PUBLIC47ARCHITECTS

3035906-LU

Northeast Design Review Board

Recommendation Meeting

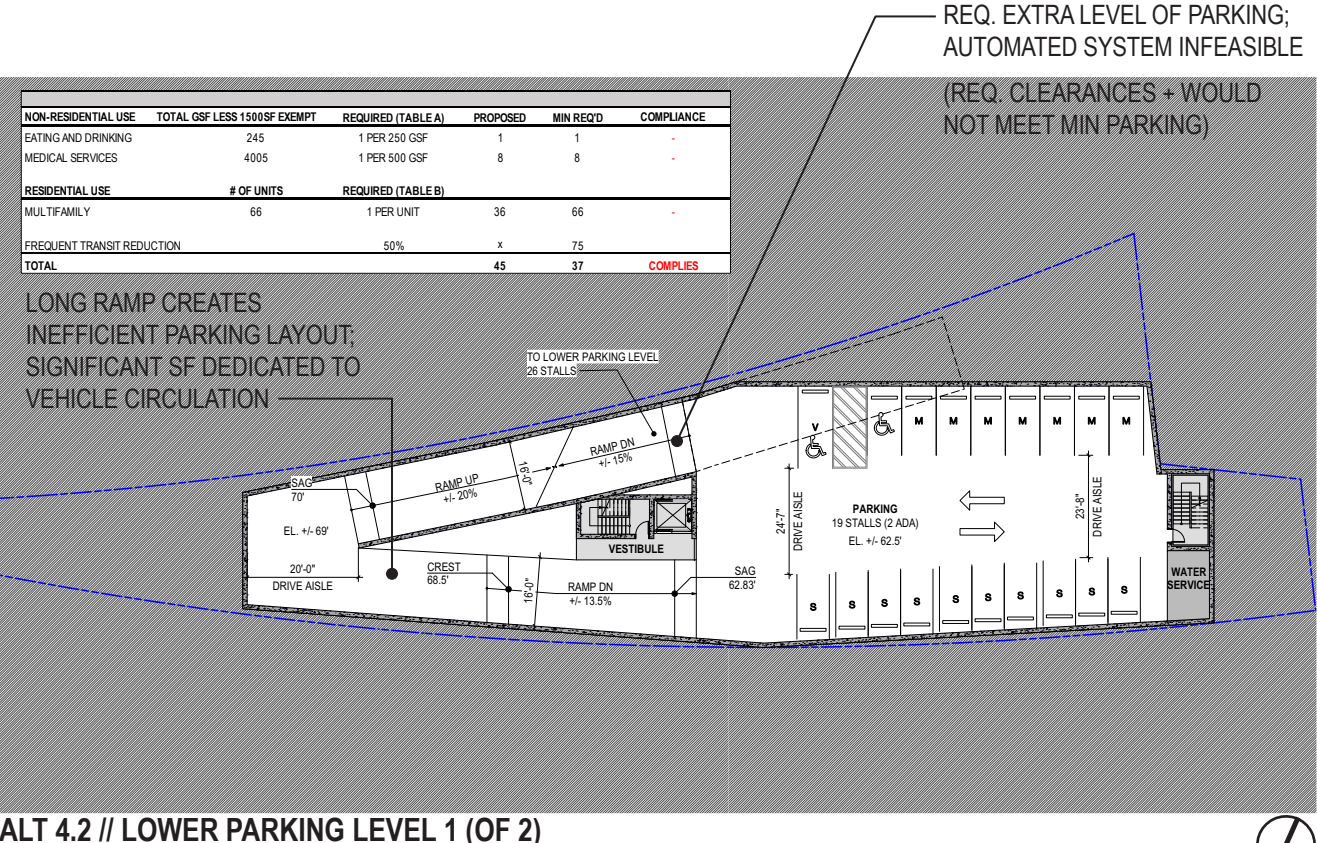
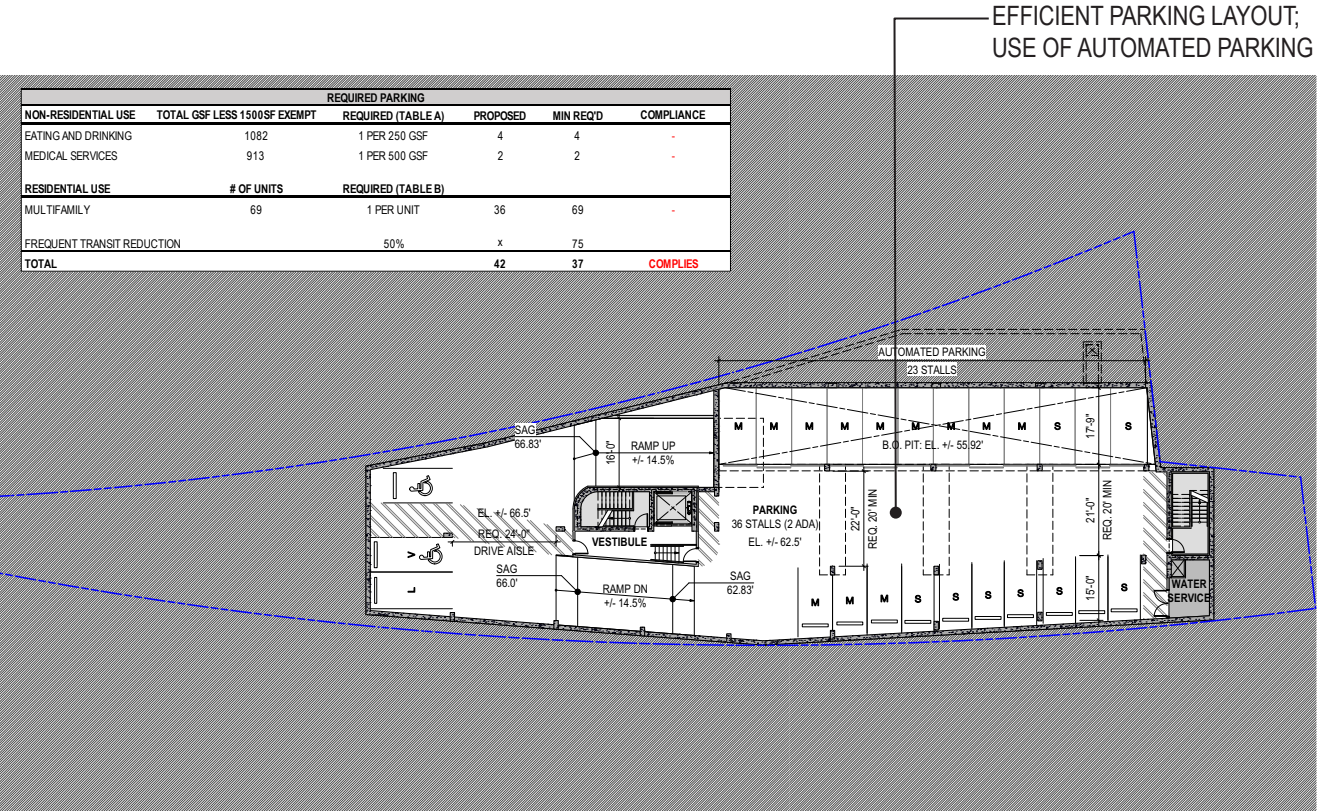
The project has advanced Preferred Alternative 3 which features preservation of the Exceptional Tree and parking access off Sand Point Way NE. Alternative 4.2 was produced at the request of the planner, but was intended to demonstrate how impractical and negatively impactful a large ramp on 39th would be to the project. It was not intended to be a viable option.

The program along 39th Ave NE in Alt 3 has been developed to be a more active, multi-layered connection to the Burke Gilman Trail while providing a widened sidewalk, covered entry, and landscape buffer. Alt 4.2 would have a street frontage dominated by the parking ramp and BOH program, generating significant blank façade with a poor, vehicular focused relationship to the street and to the Burke that is only 60’ away. Alt 4.2 would require four additional departures.

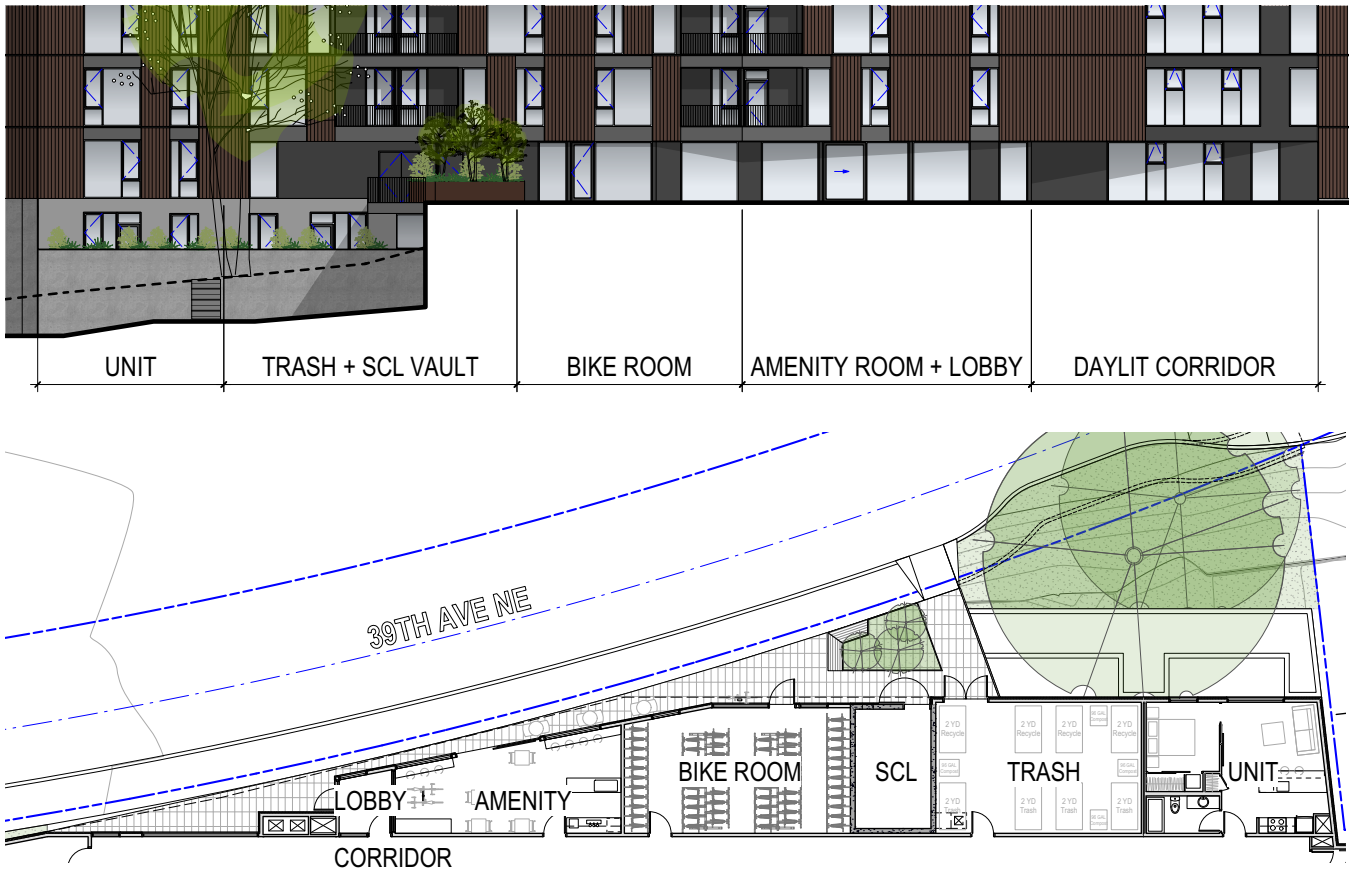
b. Maintain the grouping of lobby and bicycle storage rooms along 39th Ave NE frontage to promote street activation and create visual presence along the 39th Ave NE and Burke-Gilman Trail. Ensure that this grouping is visually expressed along the street frontage through contrast in exterior materials and extensive fenestration compared to the service and driveway areas along the same frontage. Consider blending these spaces to allow the residential lobby to encourage pedestrian activity to the bicycle storage space. (CS2-B-2, PL1-A-2, PL1-B-3, DC2-E-1)

Utilizing the steep grade change up to 39th Ave NE, the proposal maintains a secondary residential lobby, a bike lounge / potential bicycle focused commercial space and a substantial bike storage room on level 2 – giving more direct access to the Burke Gilman Trail and activating this street frontage. The service areas have been minimized, generating primary focus on the program elements that relate to the Burke Gilman trail with significant fenestration making a visual connection.

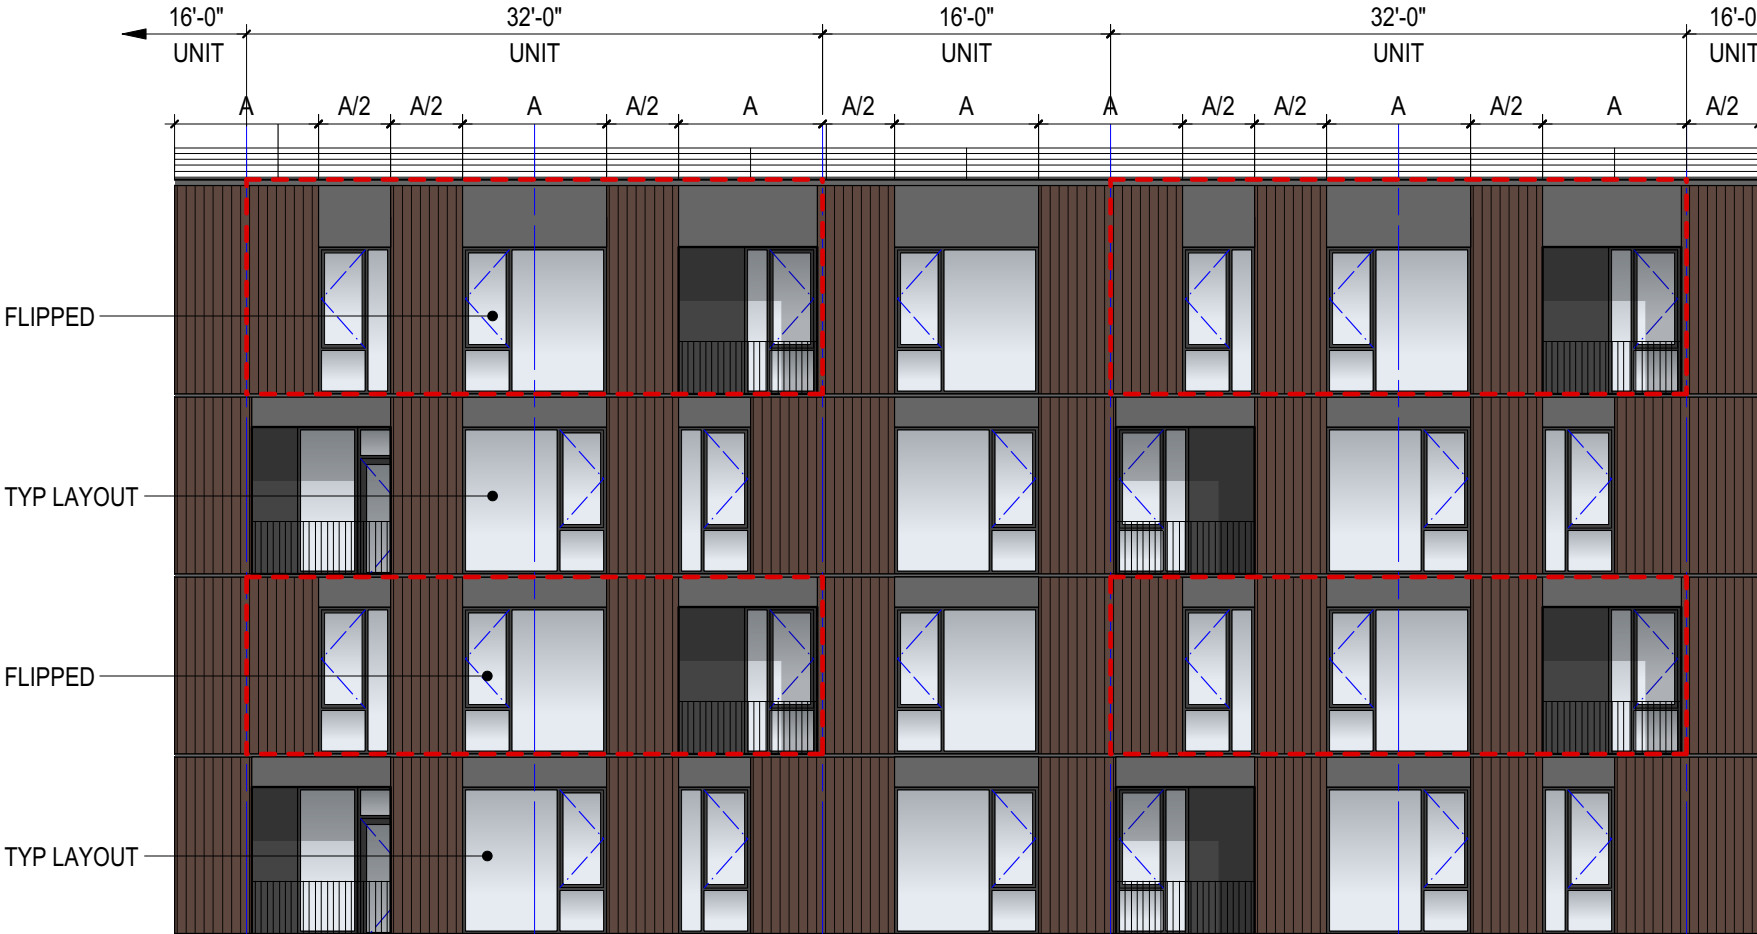
- a. Echoing public comment, Staff agrees with the applicant’s intent to preserve the existing Exceptional tree in the northwest corner of the site. Preservation of this tree will result in better meeting the applicable design guidelines to promote the incorporation of existing site features and natural elements along the 39th Ave NE frontage facing the popular Burke-Gilman Trail into the site planning (CS1-D-1, CS2-A-1)*

- b. The Arborist Report submitted with the application indicates that the Madrone tree can be preserved with development of the site, but also describes its likely sensitivity to disturbance, particularly to construction activity within the 39th Ave NE right-of-way. Due to its sensitivity to disturbance and its presence on a sloped portion of the site that will be adjacent to both building and street construction, Staff recommend submission of an Arborist Report prepared by a Registered Consulting Arborist with the Master Use Permit and Recommendation packet with a recommendation on the tree viability with development (CS-D-1)*

With the support and expertise of multiple arborists, who have performed several site visits and investigated the root structure of the Madrona, we have planned the building around the preservation of the exceptional Madrona tree in the NE corner of the site. The native tree acts as a natural buffer between the adjacent 8-story multifamily building and reducing the sense of scale and visual impact from the Burke Gilman Trail. Retaining the tree preserves a portion of the site’s natural topography, habitat and open space.

PROPOSAL WITH EAST STAIR PENTHOUSE (EDG MASSING)

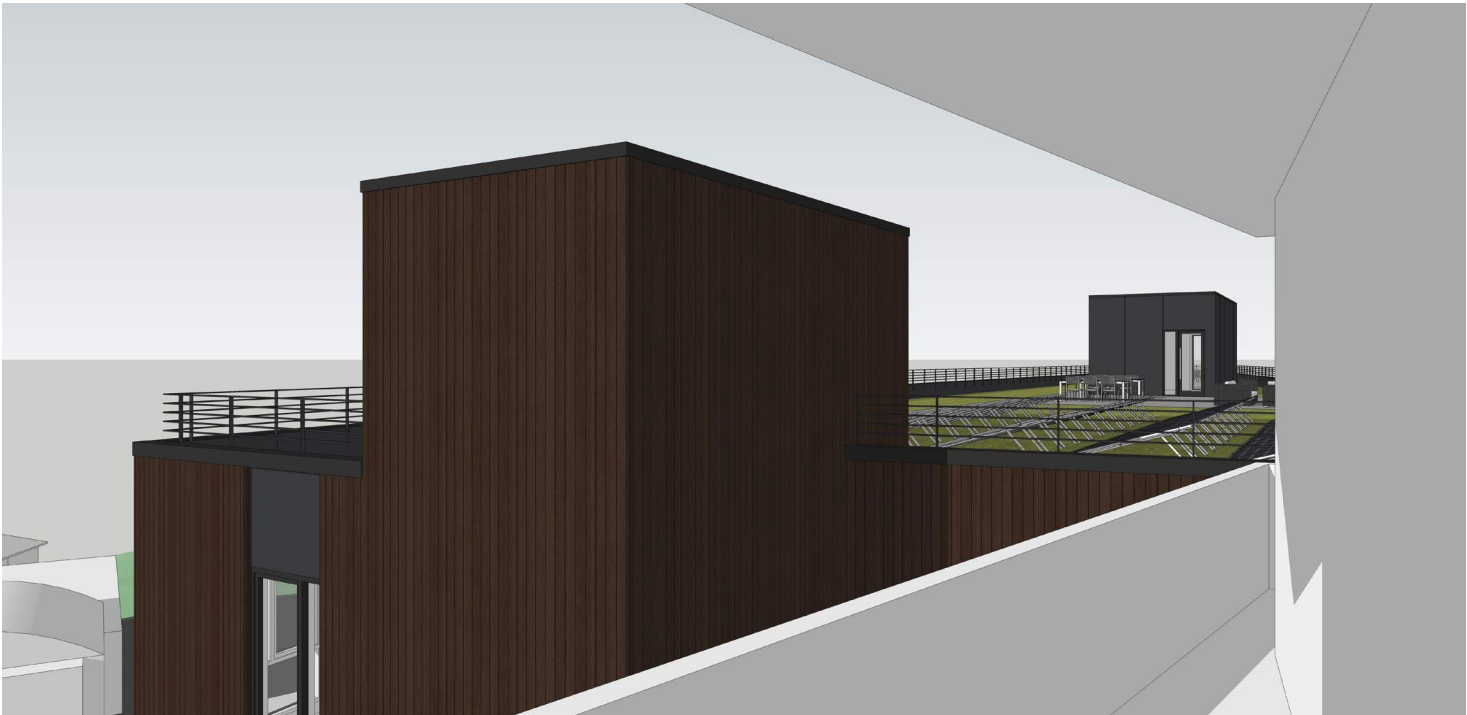
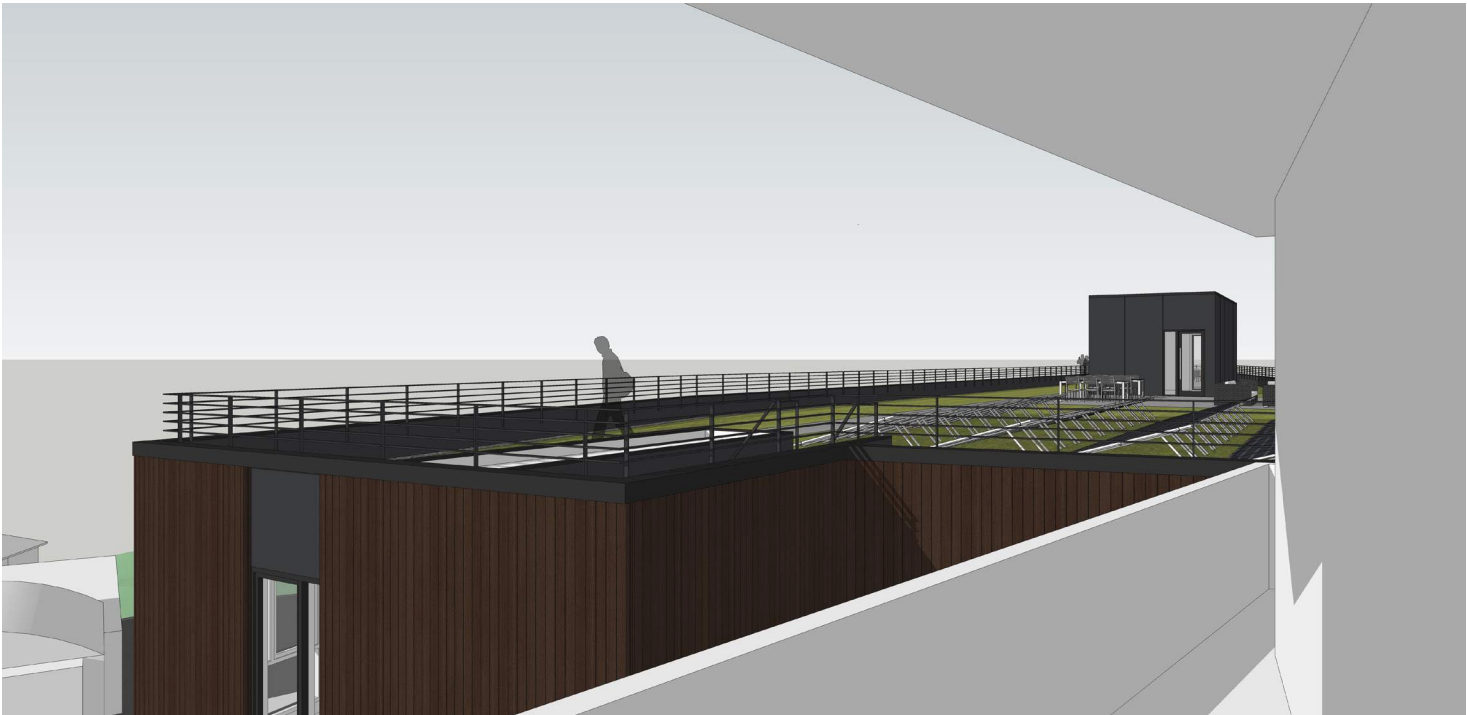
6. The Rec packet should address the relationship of the building to the adjacent units/balconies on the Laurelhurst Condo building, including dimensions between exterior walls and balconies.

The unusual site geometry results in a jogging property line, interlocking with the adjacent property to the east. An existing landscape easement prevents development in the eastern most portion of the site, preserving light and views for the existing multifamily building to the NE.

By setting the residential levels back to preserve the exceptional tree on the north side, a significant length of property line will be open – maintaining light and air for the existing building while providing a view of the tree and other landscaping.

The proposed building's second stair on the east end has been revised to eliminate the need for a penthouse at the roof. The stair is required for egress, but has been detailed to transition from interior to exterior space before reaching the roof – significantly reducing the impact to the existing building as shown on page 34.
